December 10, 1992

RE: Responses to USEPA Comments Based from the July 24, 1992, Letter

RESPONSES TO USEPA COMMENTS FROM THE JULY 24, 1992, LETTER

FIGURE 1 - Potential Sources of Groundwater Contamination

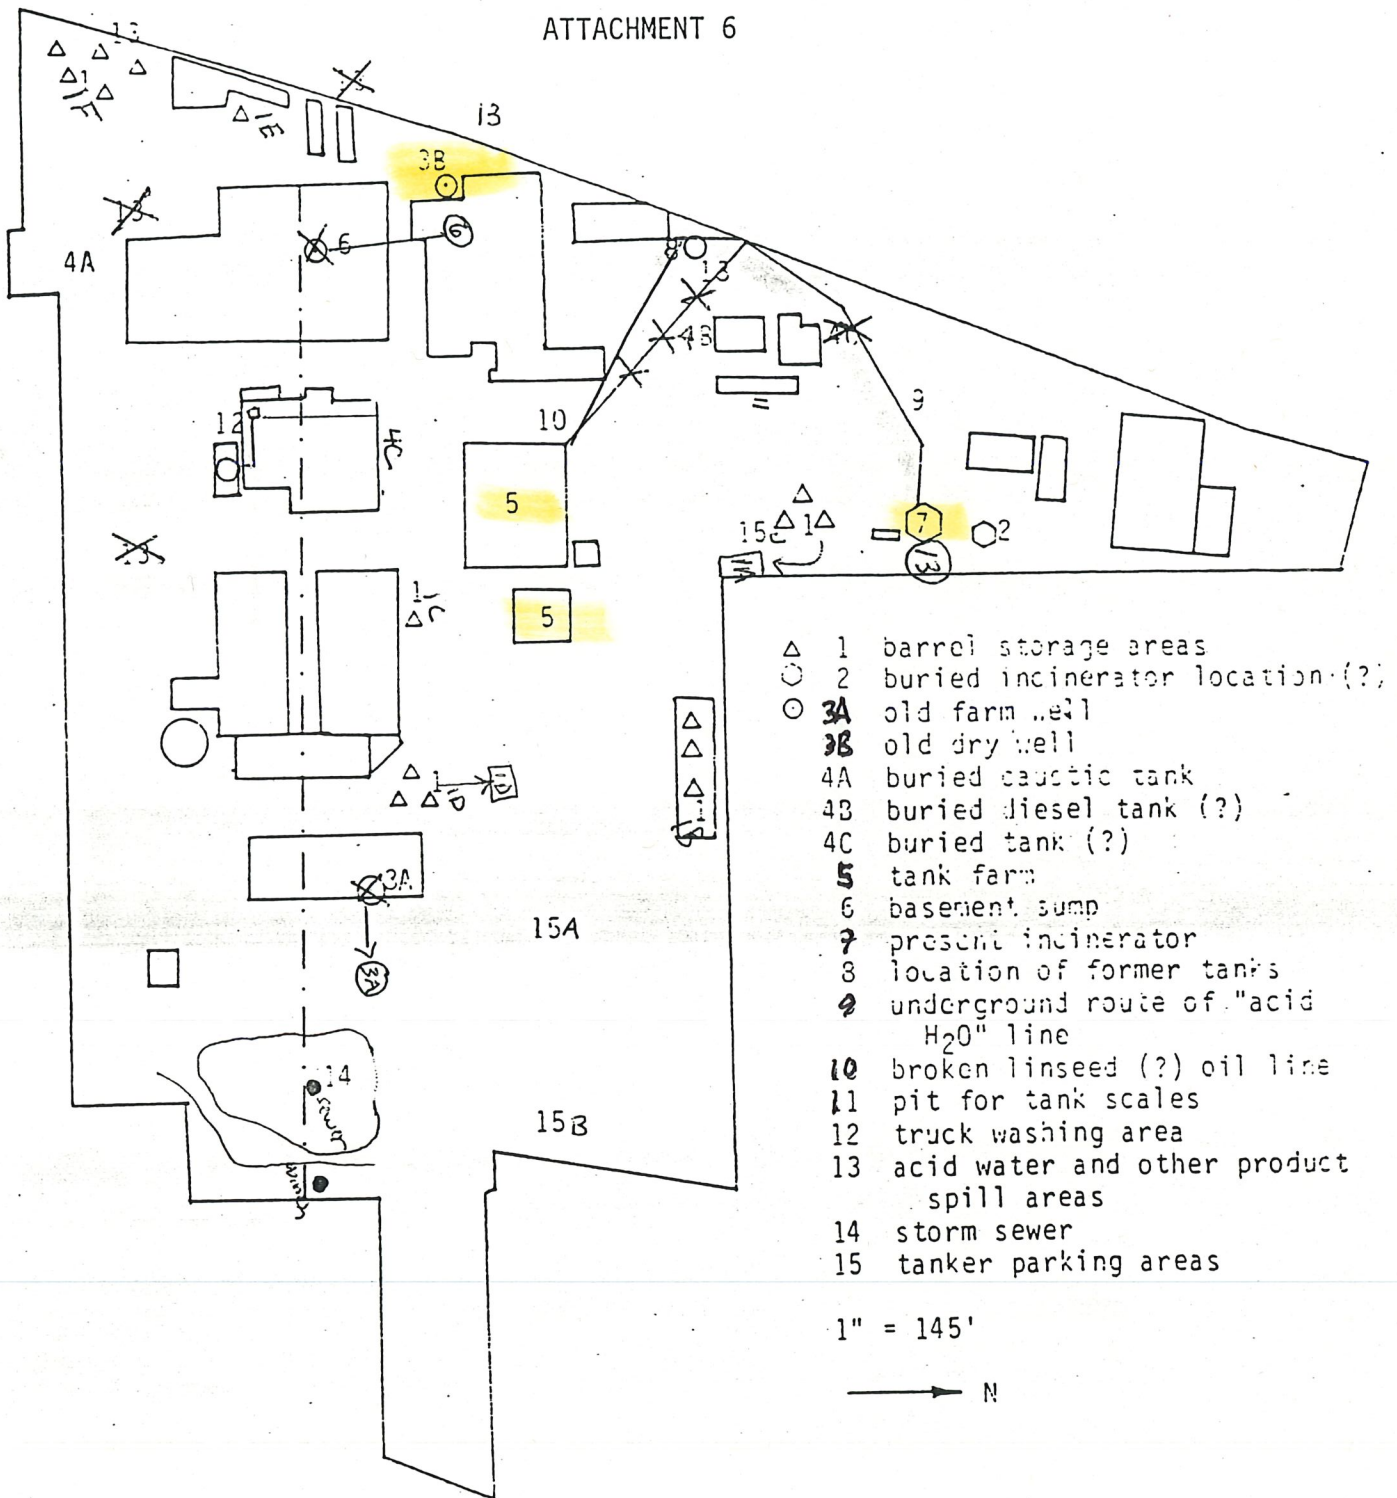
USEPA COMMENTS	RESPONSES
<p>TASK 2 - POTENTIAL SOURCES OF GROUNDWATER CONTAMINATION</p> <p>Figure 1, <u>Potential Sources of Groundwater Contamination</u>, of the Corrective Action Order on Consent (CAO) identifies 18 Hazardous Waste Management Units (HWMUs), Solid Waste Management Units (SWMUs) and/or Areas of Concern (AOC). Several have been addressed prior to the CAO and the method of remediation has been documented in Task 1 of the CAO. The remedial actions taken prior to the CAO are considered by U.S. EPA to be "interim measures" and not final solutions. Review of Task 1, Annual Reports (Task 5), and quarterly groundwater monitoring reports supports the need for further work that will determine the final solution to each of these 18 units. Each unit in Figure 1 of the CAO is listed and described below in the order found in Figure 1, which is reproduced as Attachment 6.</p> <p>Each unit must be described as it presently exists. Task 1 included only those units that had been addressed in pre-CAO remediation. In every case, there was a brief description and little post-remedial information is available. For example, much of the site is paved over which may include some of the old HWMUs, SWMUs, and AOCs listed in Figure 1 of the CAO. This may be an influencing factor in the investigation of the site and potential remediation of the sources of contamination. This factor must be addressed in the workplan.</p> <p>CCP shall conduct an investigation, sampling for Appendix IX compounds, to characterize the contamination of the soil and rock units above the water table in the vicinity of the known or suspected contaminant releases listed in Figure 1 of the CAO. The investigation shall include, but not be limited to, the following information for each unit that requires additional work:</p> <ol style="list-style-type: none"> a. A description of the vertical and horizontal extent of contamination in the soil; b. A description of contaminant and soil chemical properties within the contaminant source area and plume. This includes contaminant solubility, speciation, adsorption, leachability, exchange capacity, biodegradability, hydrolysis, photolysis, oxidation, and other factors that might affect contaminant migration and transformation; c. Specific contaminant concentrations; d. The velocity and direction of contaminant movement; e. An extrapolation of future contaminant movement; 	<p>As discussed at the September 9, 1992, meeting, three major on-site sources exist that may be contributing contaminants to groundwater. These areas include the following:</p> <ul style="list-style-type: none"> • Former dry well • Former hazardous waste incinerator/urethane laboratory area • Former tank farm storage area <p>The remainder of the areas of concern may be characterized as nonexistent or nonsignificant areas of concern. Each area is discussed in more detail (see past waste disposal practices which follows). The proper locations of the 18 areas of concern are illustrated on Figure 1 of the AOC (see Attachment A).</p> <p>CCP is proposing an alternative soil investigation approach (refer to Workplan outline). The objectives are the following:</p> <ul style="list-style-type: none"> • To collect data necessary to adequately characterize the site for purposes of determining whether or not additional corrective measures are necessary to remediate remaining on-site sources of groundwater contamination. • To quantify the risk to public health posed by off-site sources which originated from CCP operations.

USEPA COMMENTS	RESPONSES
<p>2) "<u>Buried Incinerator location (?)</u>": The old incinerator is not included in Task 1 as having been addressed prior to the CAO.</p> <ul style="list-style-type: none"> ○ Locate the incinerator and include the area in the workplan. If contamination is found, include the old incinerator in the CMS Work Plan. Include any historical remedial information on this site including any closure data. <p>3A) "<u>Old Farm Well</u>": The Old Farm Well was located and remediated as detailed in Task 1, Section 3.10. According to Task 1, "the well was located, plugged with a grout mix and abandoned". If this work was done in accordance with WDNR regulations, supply copies of the appropriate paperwork to U.S. EPA. It appears that no additional work is necessary with the "Old Farm Well".</p> <p>3B) "<u>Old Dry Well</u>": The "Old Dry Well" is included in Task 1, Section 3.9. The well was located, described (physically), fluid was removed from the well (but not totally drained), sludge was removed by backhoe, and the well was backfilled with road bond size gravel and compacted. It appears that no samples were taken to determine the extent of contamination or to characterize the contamination. It appears that the Old Dry Well has the potential to continue to be a potential source of groundwater contamination and that the soil in and around this well is likely to be contaminated.</p> <ul style="list-style-type: none"> ○ The Old Dry Well is to be included in the workplan. At a minimum, the Old Dry Well is to be located and the backfill excavated. The contaminated soil in the dry well must be characterized and the extent of contamination must be determined. If contamination is found, this unit must be included in the CMS Work Plan. If any additional historical remedial information exists beyond that which was included in Task 1, it must be incorporated into the workplan. ○ Paragraph 11.d of the CAO identifies the soil in the area of the "abandoned dry well" as having known soil contamination. The old dry well is located in a major hot spot of groundwater contamination. 	<p>Based on employee recollections, the barrels storing raw materials and finished products were generally maintained in good condition. These areas are now paved, preventing direct contact with surface soils. These areas are not suspected sources contributing to groundwater contamination.</p> <p>2) <u>Buried Incinerator Location</u> There is no buried incinerator at this location. Rather, there is a concrete culvert buried east of building 7 (near back door of former urethane laboratory). A backhoe was used to bury the concrete about 5 feet deep. This is not a suspected source of contamination.</p> <p>3A) <u>Old Farm Well</u> The location on the original map is incorrect. Employee recollections are identical to the narrative provided in the Hatcher-Sayre Construction and Documentation Report. No further work is necessary.</p> <p>3B) <u>Old Dry Well</u> Employee recollections are that from approximately 1952 through 1968 the old dry well was used to dispose of acid water. The former dry well consisted of a well pit with a sand and gravel base, which was located west of building 5. Employee recollections agree with the dry well abandonment procedures described in the Hatcher-Sayre Site Construction Documentation Report.</p> <p>This area is now paved and located adjacent to shallow dolomite pumping well W-34 and overburden drain RC-2. This is a potential major source area of concern. Further investigation is necessary to determine if this is a continuing source of groundwater contamination.</p>

USEPA COMMENTS	RESPONSES
<p>4A) "<u>Buried Caustic Tank</u>": Task 1, Section 3.11, states that "the tank was located, the liquid within diluted and drained, sediment removed and taken to the storage pile, and the tank was filled with four yards of concrete after inspection."</p> <ul style="list-style-type: none"> ○ Include this unit in the workplan. At a minimum, the soils around and beneath the tank must be sampled to determine the extent of contamination, if any. Determine the fate of the contaminated soil that was taken to the storage pile. If contamination is found, this area must be included in the CMS Work Plan. 	<p>4A) <u>Buried Caustic Tank</u> Employee recollections are identical to the description of the tank abandonment procedures. The tank was not known to have leaked. Visual inspection of the tank by plant personnel confirmed this during the tank abandonment. This area is not a suspected source contributing to groundwater contamination.</p>

USEPA COMMENTS	RESPONSES
<p>5) <u>"Tank Farm"</u>: Task 1 does not mention this unit and thus, it appears that the tank farm was not addressed in pre-CAO remediation.</p> <ul style="list-style-type: none"> ○ This area must be included in the workplan. At a minimum, any release must be documented and soils analyzed to characterize the release, if any, and the extent of the release. If contamination is found, include this area in the CMS Work Plan. ○ Paragraph 11.a of the CAO identifies the tank farm as an area of known soil contamination. The contamination was identified during soil boring and groundwater monitoring well installation. This possibly is the area that monitoring wells 43 and 44 have identified a major hot spot of groundwater contamination. 	<p>The contaminated soil that was excavated was treated by mixing and aeration. Field-screening results (PID confirmed by laboratory analyses) of less than 10 ppm were required for complete remediation. The treated soil was then used to construct on-site landscaping berms along the southeast and northeast property limits.</p> <p>The former tank location is not a source area of concern contributing to groundwater contamination. The contaminated soil was sufficiently excavated during the tank removal.</p> <p>5) <u>Tank Farm</u> The tank farm was relocated and improved. Triad Engineering Inc. (TEI) oversaw all activities concerning the tank farm renovation. The former tank farm was approximately 50 feet east of the current location. The former location is at the present pumphouse (Bldg. 65) and unloading bay area (Bldg. 67). The former tanks were supported on a stone (No. 1 rock) base, which was bermed with dirt. The tanks were tested and found to be adequate (none were leaking). The new tank farm has a concrete dike with 33,000 gallons spill containment capacity.</p> <p>Although the tanks did not leak, considerable spillage may have occurred during tank filling operations. According to employee recollections, the styrene tanks were overfilled occasionally resulting in spills which may have infiltrated the ground surface.</p> <p>The tank farm area is a potential major source area of concern. Further investigation is necessary to determine if this is a continuing source of groundwater contamination.</p>

USEPA COMMENTS	RESPONSES
<p>13) "Acid Water and Other Product Spill Areas": A minimum of five areas were defined as spill areas on Figure 1. No spill area was specifically addressed in the pre-CAO remediation as outlined in Task 1.</p> <p>○ Each area in Figure 1 and any other area identified by CCP must be included in the workplan. Each area where contamination is found must be included in the CMS Work Plan.</p>	<p>13) <u>Acid Water and Other Product Spill Areas</u> The locations for some of the spill areas are incorrect (see Figure 1). No product or raw material was spilled at two areas identified on the map.</p> <p>Products that do not contain hazardous constituents need not be addressed under this corrective action.</p> <p>In years past, approximately from 1965-1972, an acid water tankwagon was parked by the old dry well. Spills of acid water occurred when the tankwagon overfilled, which may have impacted the area immediately west of the dry well.</p> <p>There were no reaction water lines at this time to carry the reaction water from production areas to the incinerator area. Thus, the reaction water was trucked up to the incinerator area and transferred into the storage tank. Spills of acid water occurred at the former hazardous waste incinerator area.</p> <p>Spills did not occur at the south end of the facility. This area was used primarily for employee parking. Field-screening results for soils excavated during placement of the storm sewer line clearly indicate that these soils were not impacted (see Attachment C).</p> <p>On rare occasions, employees recollected hose leaks from phthalic and maleic tanks located near the old dry well. Phthalic and maleic materials solidify at ambient temperatures. This area is now paved and is not an area of concern for groundwater contamination.</p>

Comments from the cover letter and Attachments 1, 2, and 6 of the July 24, 1992, letter were addressed. (Attachments 3, 4, and 5 provide information but do not contain USEPA comments and therefore, were not addressed.) The past disposal practices at the 18 on-site areas of concern are also discussed. Figure 1 of the CAO was revised by Craig Bostwick to accurately locate these 18 areas.
